Red Hill LNAPL Migration – Preliminary Assessment

Figure 1. A map showing the probable LNAPL flow path based on lava bedding geometry

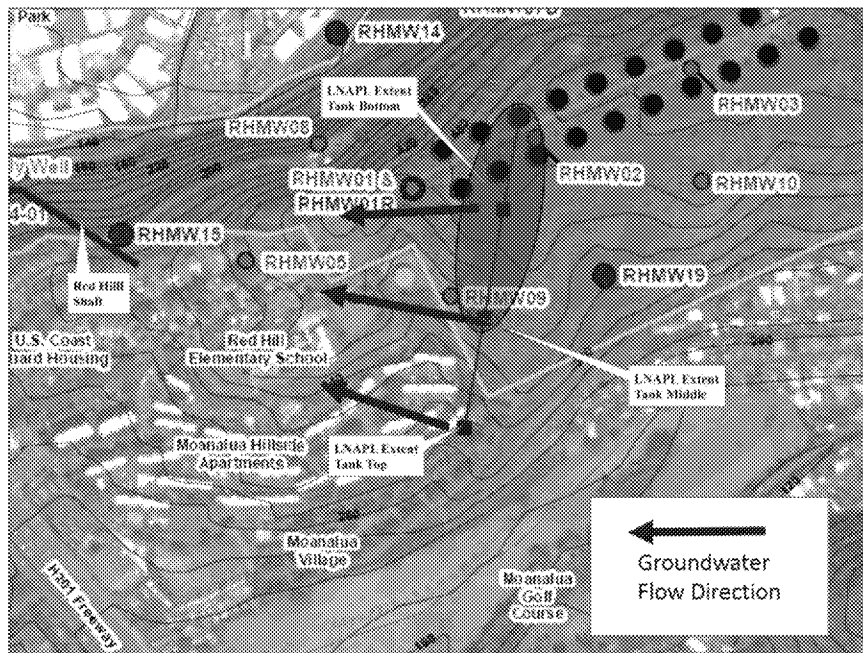
Commented [D1]: I would include an oval extending from immediately below the tank to that shown and specify that the distribution would be highly dependent on the magnitude/rate of release – smaller volumes/rates would be able to sink to the wt in a near vertical trajectory whereas a larger release would be distributed in a generally SSWesterly direction.

Commented [WR2R1]: Modified oval to include UST 5, thanks.
